Planning Commission Staff Report

Subject: Rezoning Vote Report

Petition: P.Z. 28-2007 THF Chesterfield Seven Development (THF Chesterfield Seven Development LLC)

RE: P.Z. 28-2007 THF Chesterfield Seven Development

CONCEPTUAL SITE PLAN

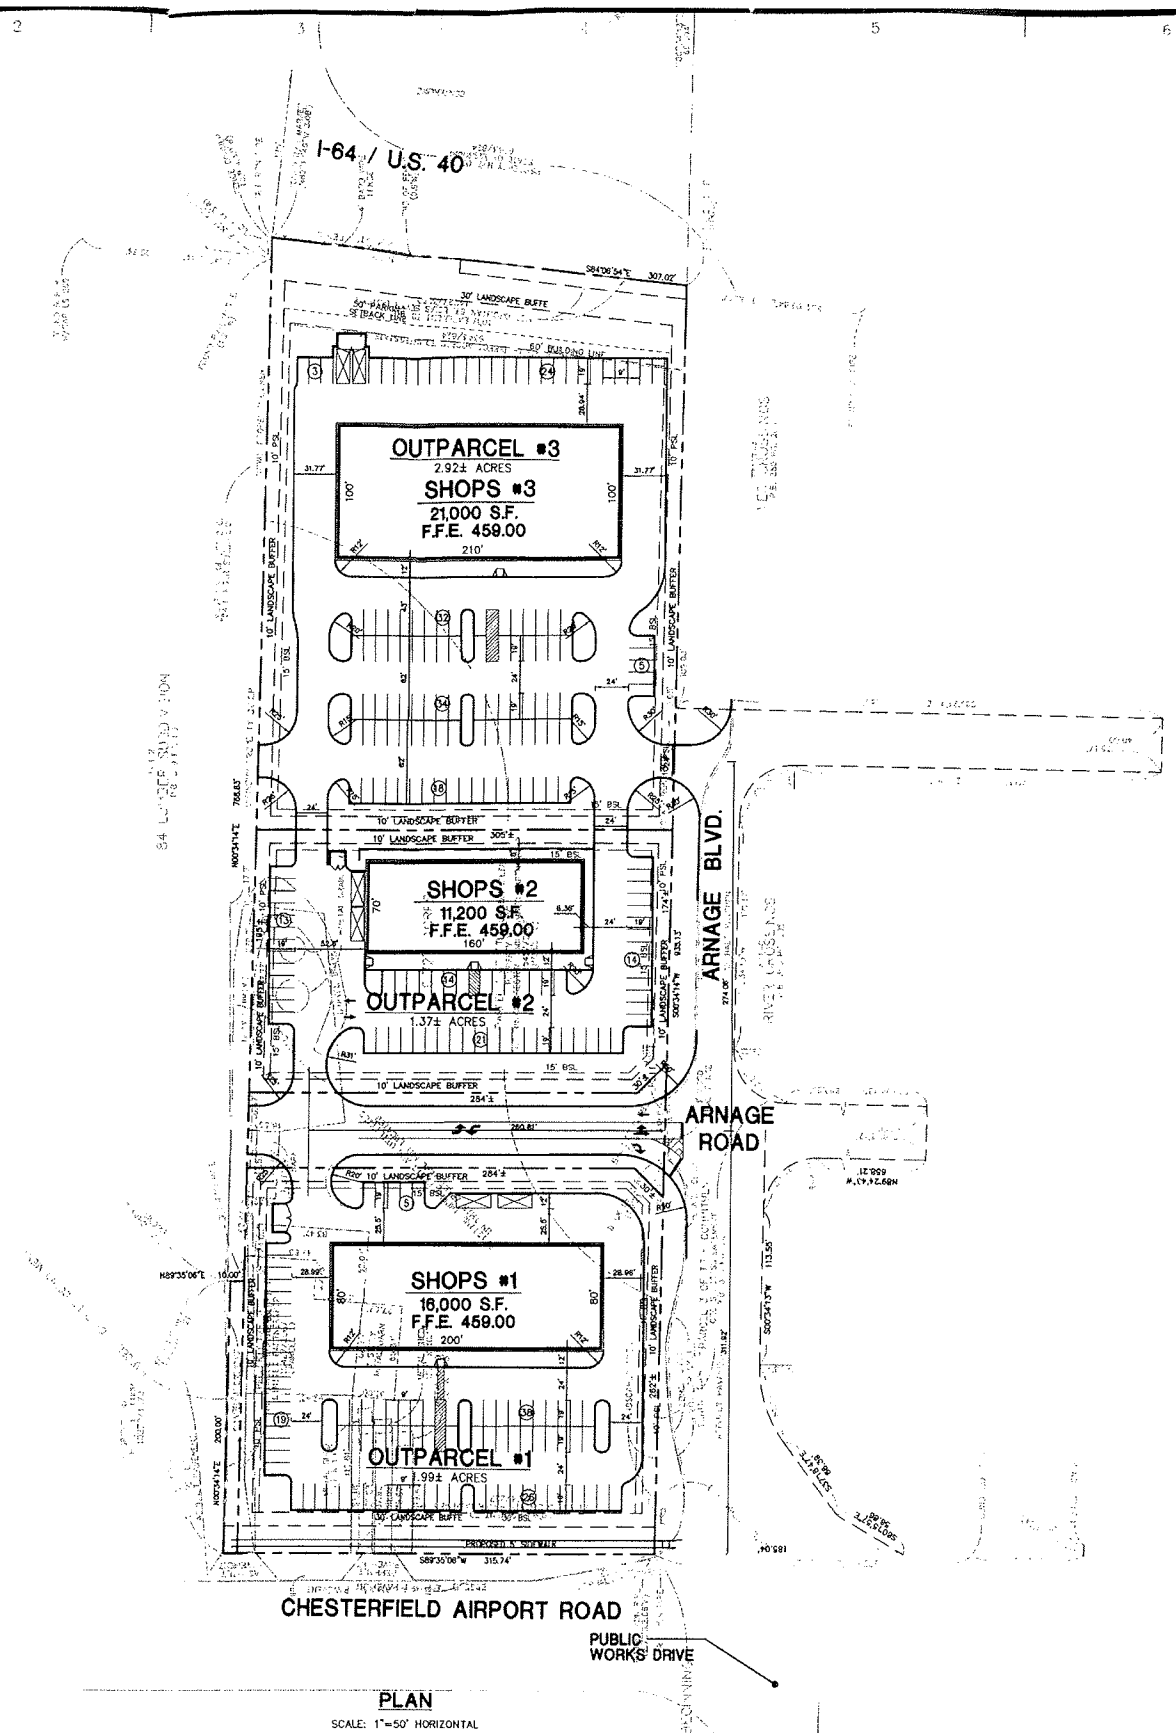
- Please be advised that cross access will be required to be provided to 17505 Chesterfield Airport road which is located to the west of this site. The revised plan does not show that cross access can be provided.

Petitioner's response: Petitioner understands from conversations with staff that this requirement has been deleted.

REZONING PLAN & CROSS SECTION PROFILES

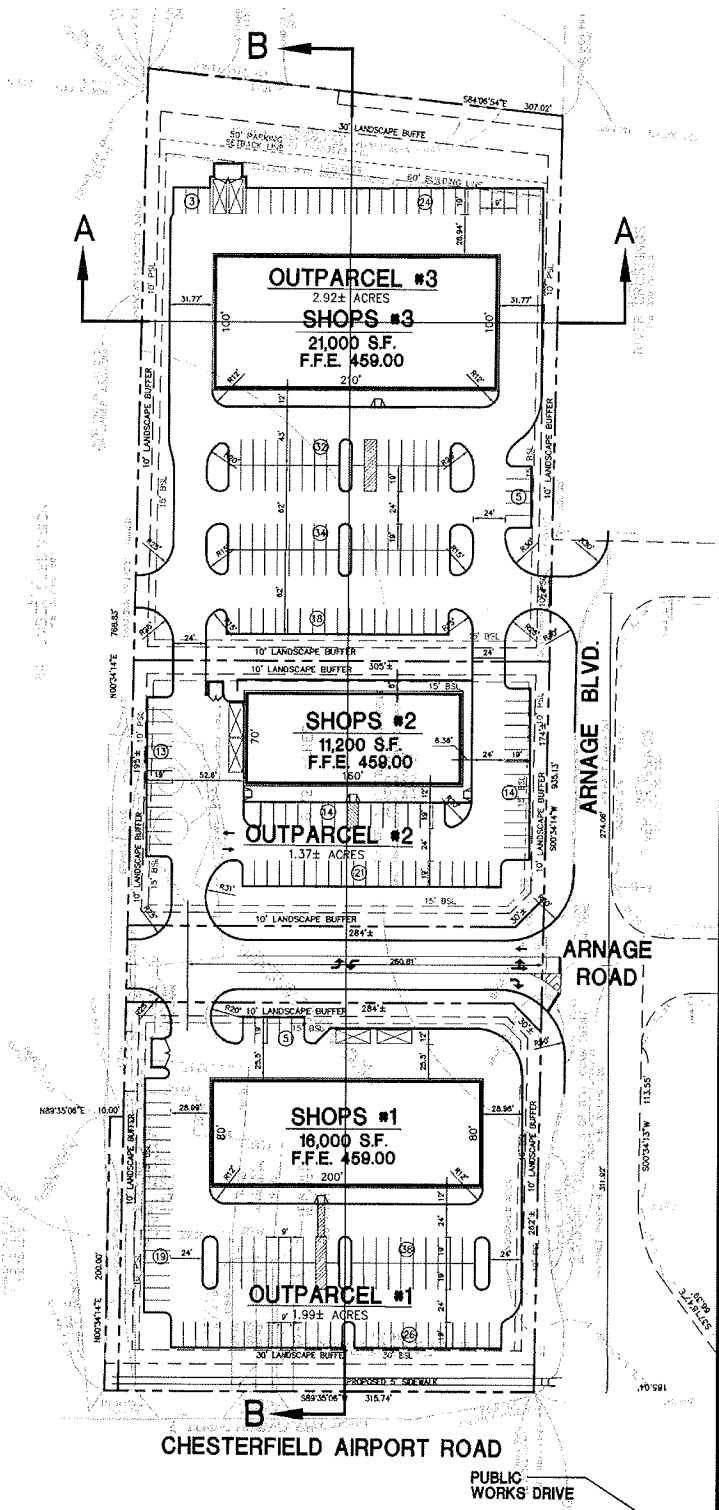
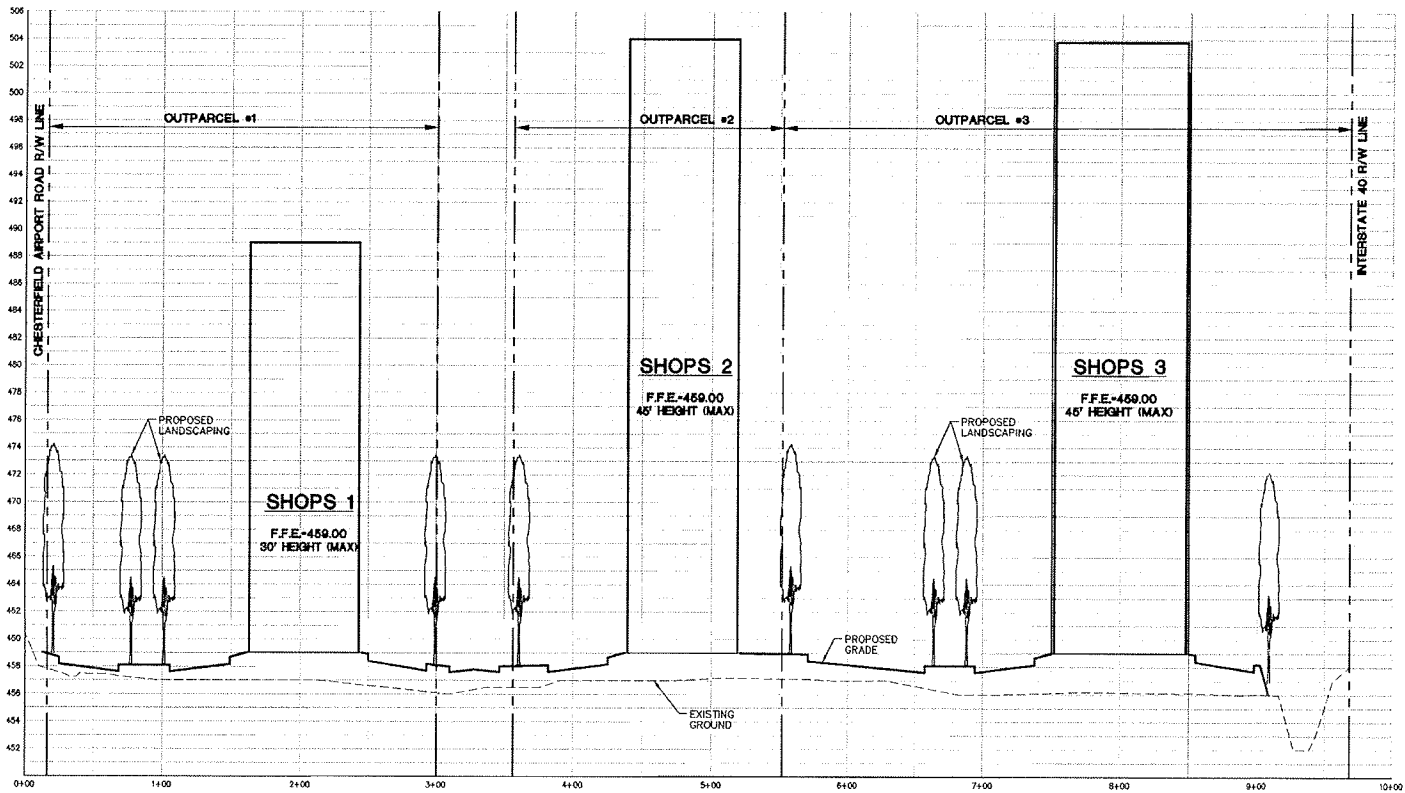
3. The petitioner has requested a maximum building height of three (3) stories of forty-five (45) feet. City of Chesterfield Ordinance 1747 which provides performance standards for retail development states that "The maximum building height shall be two level stories from floor elevation at grade (exclusive of mechanical equipment)."

1. The maximum building height shall be two level stories from floor elevation at grade (Per City of Chesterfield Ordinance 1747).

Petitioner's response: Petitioner is requesting three (3) stories or forty-five (45) feet. This is consistent with developments in the surrounding area including River Crossings (Lamborghini of St. Louis).

NOTE: MAXIMUM BUILDING HEIGHT, EXCLUDING EQUIPMENT AND SCREENING IS THREE (3) STORIES OR FOURTY-FIVE (45) FEET (AS MEASURE FROM GRADE) WHICHEVER IS LESS
NOTE: THERE ARE NOT ANY EXISTING TREES ON-SITE
